KARACHI MUNICIPAL CORPORATION.

KMR.CDD.LyQ.1916.01

ORDERS UNDER SECTION 96 (2) OF ACT III OF 1910.

PLAN OF PROPOSED UPPER FLOORS
ON PLOT NO 151 SHEET K.8. LYAREE Q.8

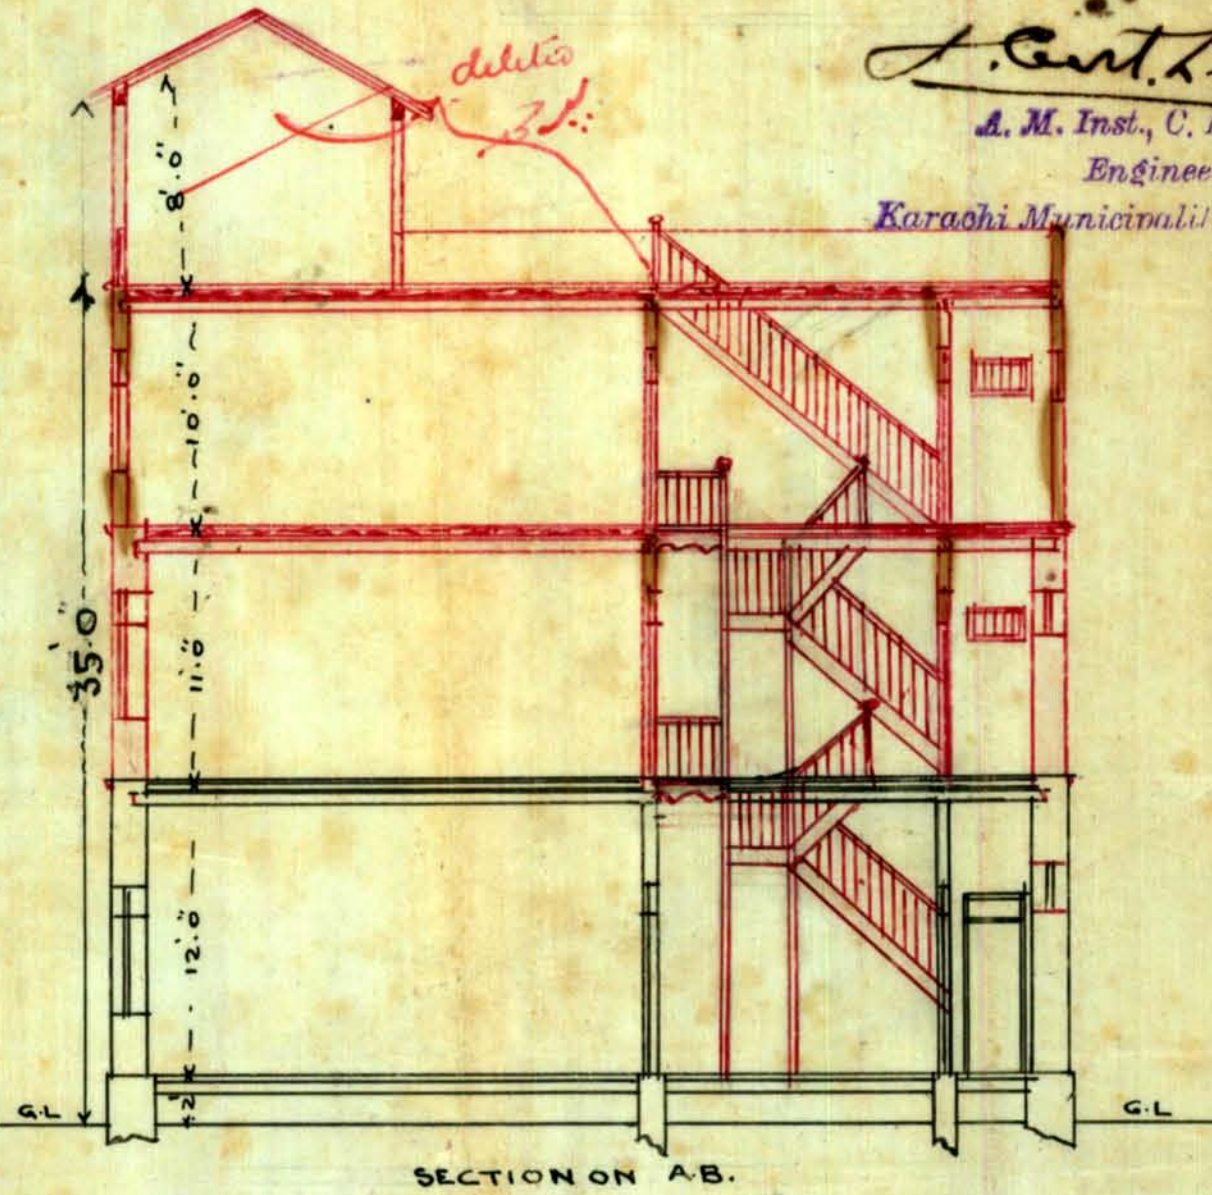
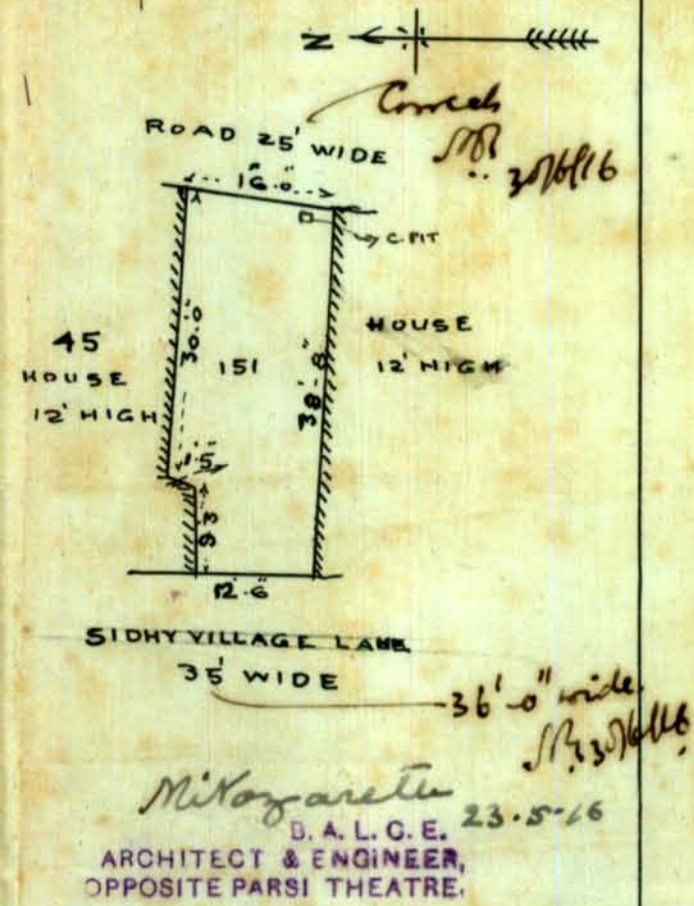
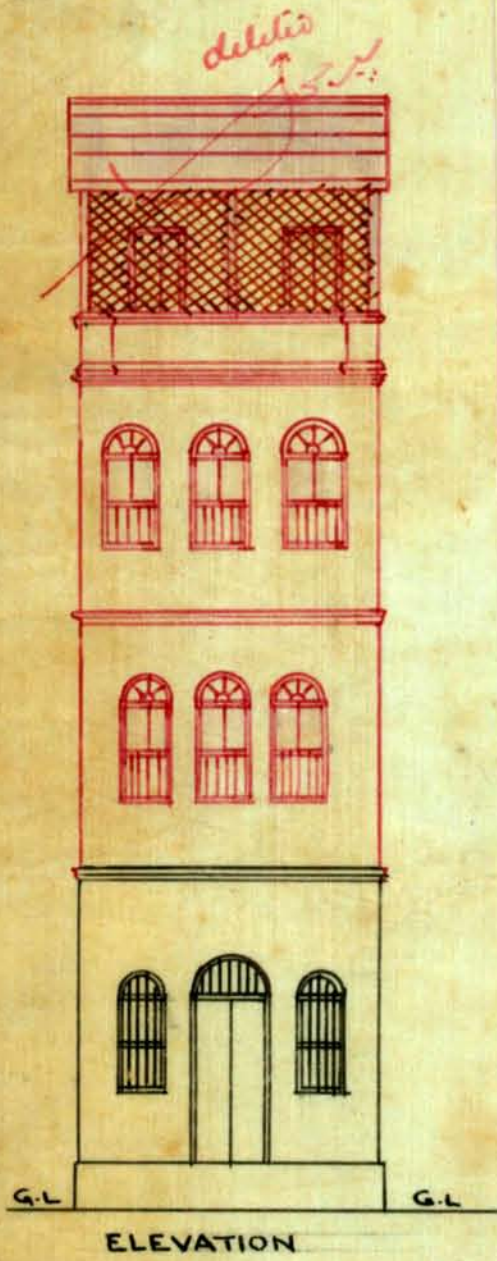
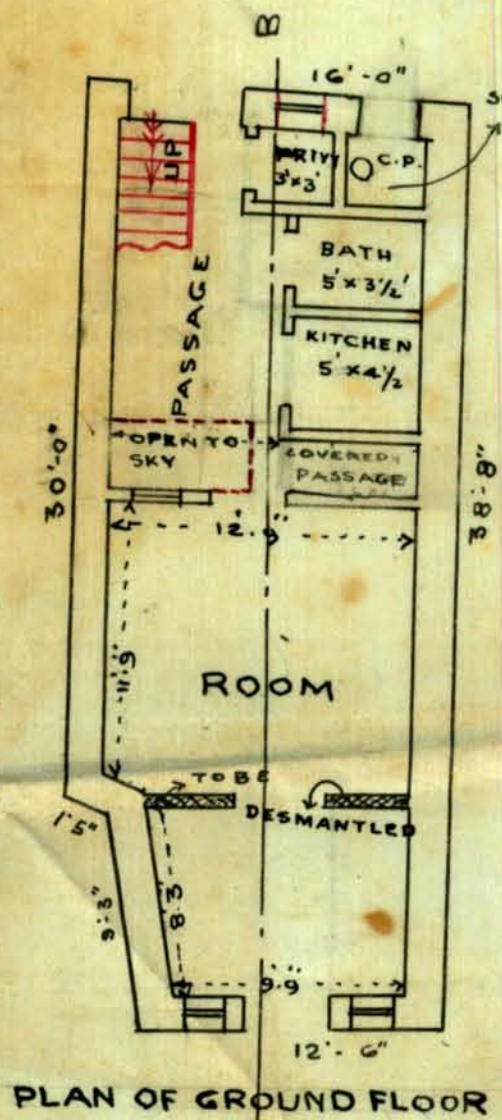
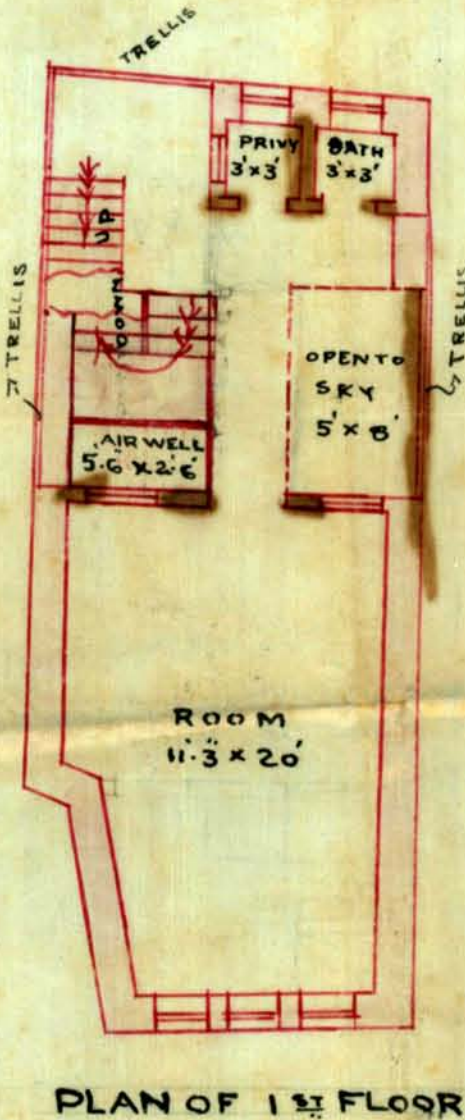
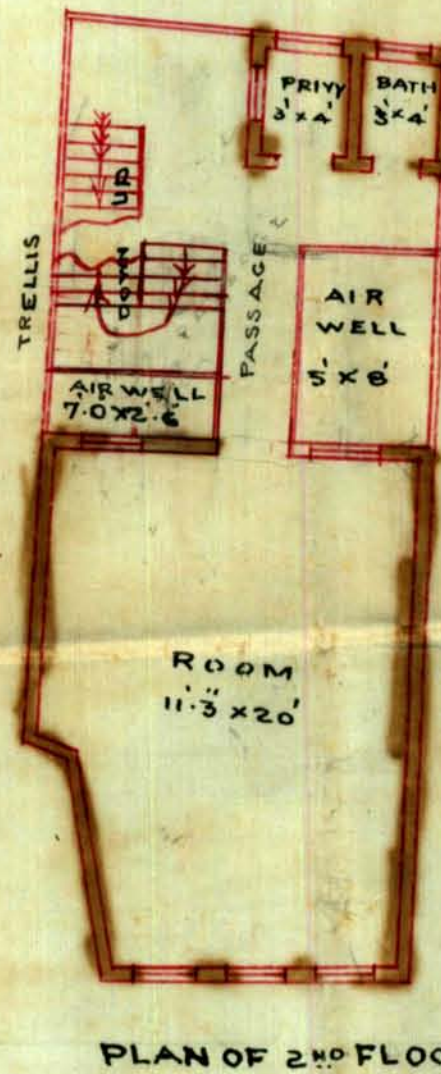
With reference to his application dated 19th --
current submitting amended plan for plot No: 151, K-2 Lyari
Quarter, Mr Pirmahomed Yarmahomed is informed that he has appar-
ently made no amendment in the plans as submitted in order
to ventilate the building as required in this Office No. 4510
dated 7/24 June 1915.

With reference to your No E. 4510 of 2nd June 1916, I humbly beg to state that the 1st floor of proposed addition to house on plot No 151, K-8, Lyaree Quarter consists of only a covered shed supported on posts with trellis work in front for sleeping purposes, & behind this is an open terrace.

The existing partition wall in the ground floor will be removed as shown in the plan & the room will be ventilated by two windows & ventilator over door opening on to the street & will to a great extent be an improvement on the present condition. Ventilation will also be effected from the staircase well & I humbly beg to submit there will be no deficiency in ventilation & I humbly beg to request that you will kindly pass the same for your decision upon the plan for which favour I will be greatly obliged.

F.C. detached and
beg to report that the rooms
are too deep and devoid
of any ventilation. However
it may be forwarded to
the Health officer for early
report.

The plan is returned as it
is. Nothing is done to provide
ventilation to the rooms.

K-8 Tyari Quarter, Mr Pirmohamed is informed that this plot is too small to carry a four storied building. The rooms will be dark and devoid of ventilation. The plan is disapproved and returned for amendment.

*The rooms will be crack.
 open space provided is very inadequate
 to ventilate the rooms.*

I beg to report that the plot is too small to
 carry four storeys - It should not be allowed.
 Request order

Remarks Sir, With reference to this I beg to
 report that the applicant wants to build
 four storeys house on such a small
 plot which should not be allowed. Request
 your order. Under Government Control. *Yours obedt*
Nathan

With reference to his application, dated 23rd May 1916, Mr. Parmahamed Jammahamed is informed that the plan submitted by him for building a house on plot No. 151, Survey Sheet K8, situate in Sudhi Village Lane Street, Syan Quarter, is approved, and permission to build in accordance therewith is granted. The building to be erected subject to the Byelaws and Rules of the Municipality.

Sir,
 With reference to your No. E. 5171 of
 1st July 1916, I beg to resubmit a set
 of plans for building upper floors to
 building on Plot No. 151 Sheet R. 8
 Dyaree Quarter with the upper 3rd
 floor deleted, as indicated in your
 No. E. 4510 of 7th June 1916.
